NUMBER: 82-6

DATE: 6/9/82

- A. Overheating at Idle RPM — MIE 230/260/340 Model Engines
- B. Shift Cable Adjustment and Installation on Mercury Marine Transmissions with Mechanical Shift - MCM 228TR, MCM 255TR and MCM 330TR-TRS Models
- C. Tune-Up Specifications for Hi-Performance Stern Drive (MCM) Engines — MCM 400 Cyclone and 475 Turbo

Figure 1. Removing Tee Fitting and Air Bleed Hose

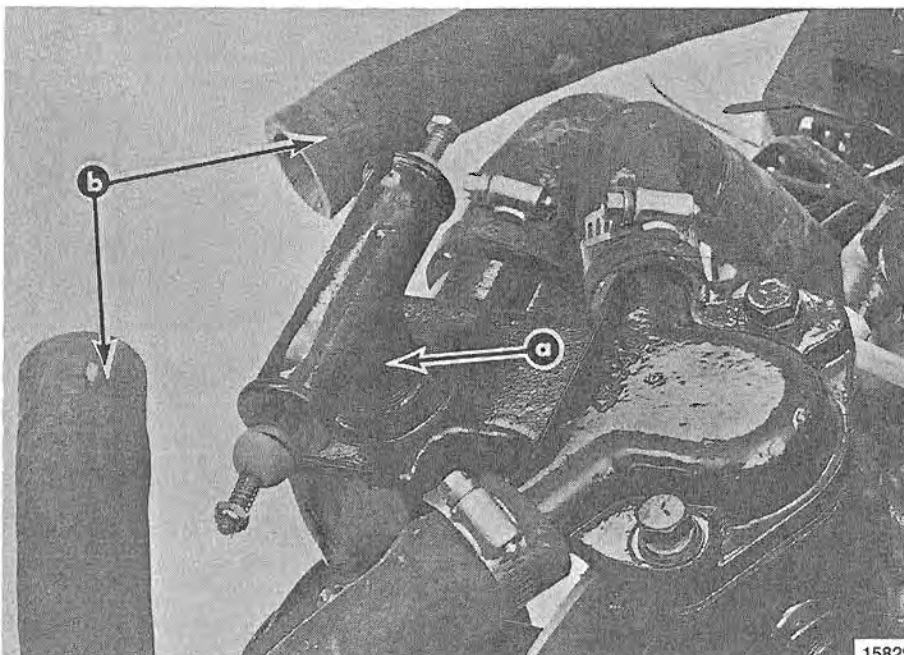
Under certain operating conditions, the above model engines may overheat at idle RPM. Usually by increasing the engine RPM, the engine temperature will drop.

If this condition exists, order a new Tee Fitting (22-98477A1). Install as shown in Figures 1 and 2.

- a - Remove Clamps and Hoses
- b - Remove 90° Elbow
- c - Install 1/8" Pipe Plug
- d - Remove Tee Fitting

Figure 3. Shift Cable Minimum Travel

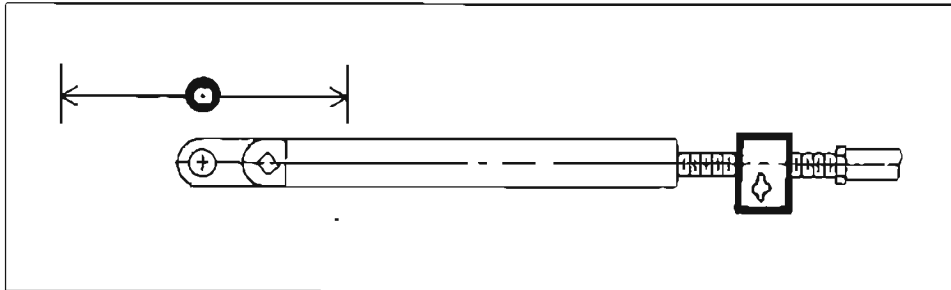
Remote Control shift cable **MUST** have a **minimum travel of 2-13/16" (71.4mm)** [ideal 3" (76.2mm)] from full forward to full reverse (Figure 3).

a - 2-13/16" (71.4mm) Minimum, 3" (76.2mm) Ideal

Figure 4. Transmission Shift Rod Dimension

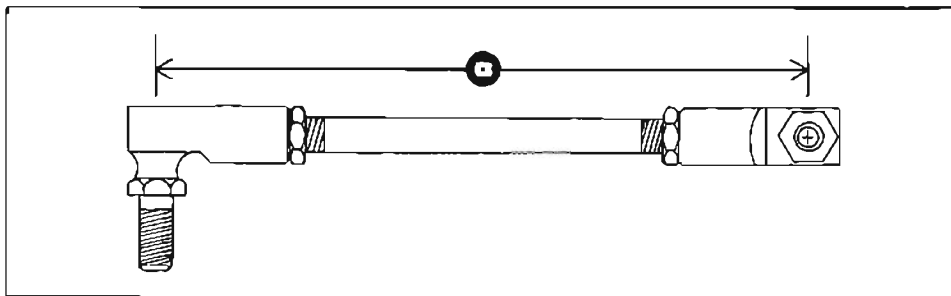
Transmission shift rod assembly is preset to dimension shown in Figure 4 and **MUST NOT** be changed. Check dimension to ensure that it has not been changed.

a - 5-1/32" (12.8cm)

Figure 5. Adjusting Shift Cable Barrel

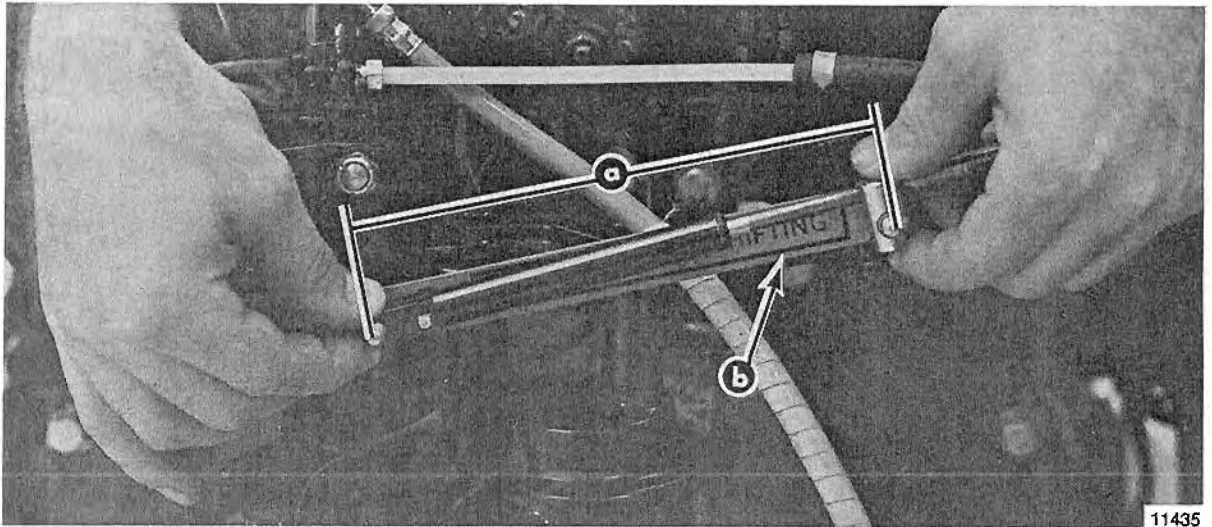
Adjust shift cable barrel until the center of the barrel is exactly 7 $\frac{1}{8}$ " (18.1cm) from the center of the hole in the cable end guide.

- a. Place Adjusting Tool on studs and reinstall spacer on anchor stud.
 - b. Adjust shift cable barrel to align attaching holes with studs.
 - c. Remove Adjusting Tool from studs.
5. Being careful not to disturb barrel adjustment, install cable on studs and secure with flat washer, spacer and elastic stop nuts. Torque nuts to 60-70 lbs. in. (6.8 - 7.9 Nm).

a - 7-1/8" (18.1cm)
b - Shift Adjustment Tool
